GO EAST LANDFILL CLOSURE PLAN

GO EAST LANDFILL
4330 108th Street SE
Everett, Washington 98208

Revised: October 28, 2015
Third Party Review updates August 8, 2016
Snohomish County Hearing Examiner Decision Issued December 8, 2017

January 2018 Update

DETAIL 2
NOT TO SCALE

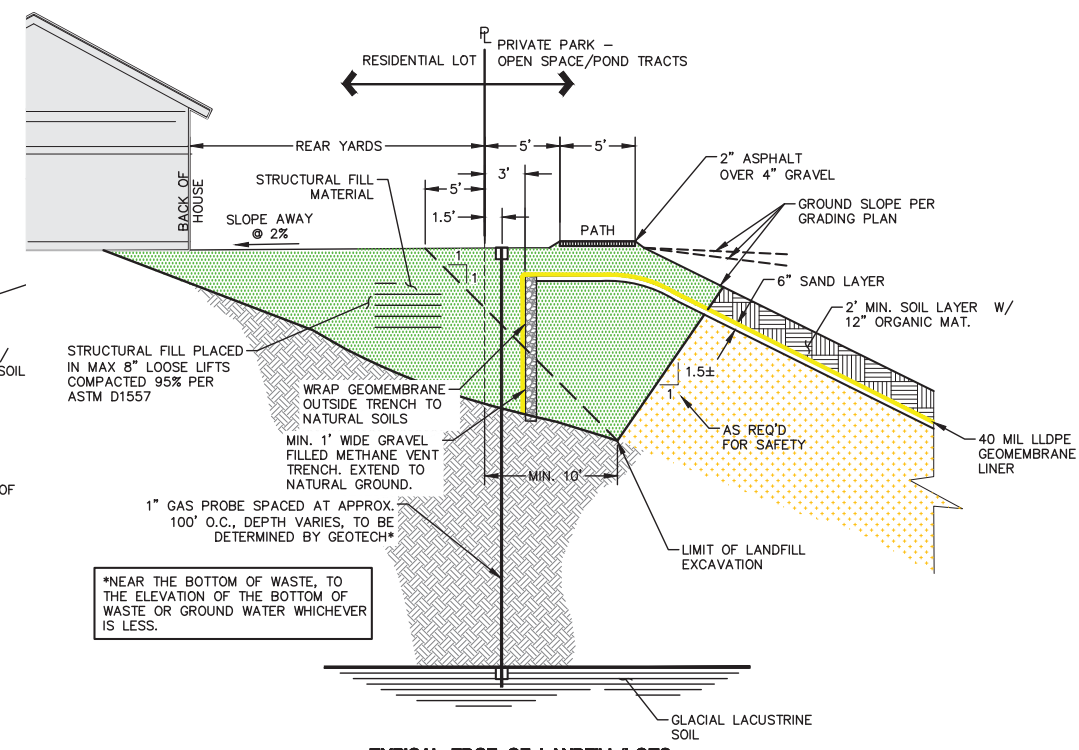
Deficiency 5: Detail 2 on sheet 3 of the design drawings in Appendix D of the LFCP shows the water level in the detention pond at the same elevation as the top of the two-foot soil layer above the geomembrane. Water at this elevation could seep into the soil layer and apply a hydraulic head on the single geomembrane

Alternative Approach 5: To the extent practical, the pond should be lowered to prevent seepage back into the soil layer. Alternatively, a zone of the low-permeability soil using for the cover on the 2H:1V slope could be placed around the perimeter of the pond to limit flow into the soil layer during detention events. **The detail on Sheet 3 of 3 of Appendix D has been corrected to reflect this concern. The pond overflow elevation is one foot below the pond liners.**
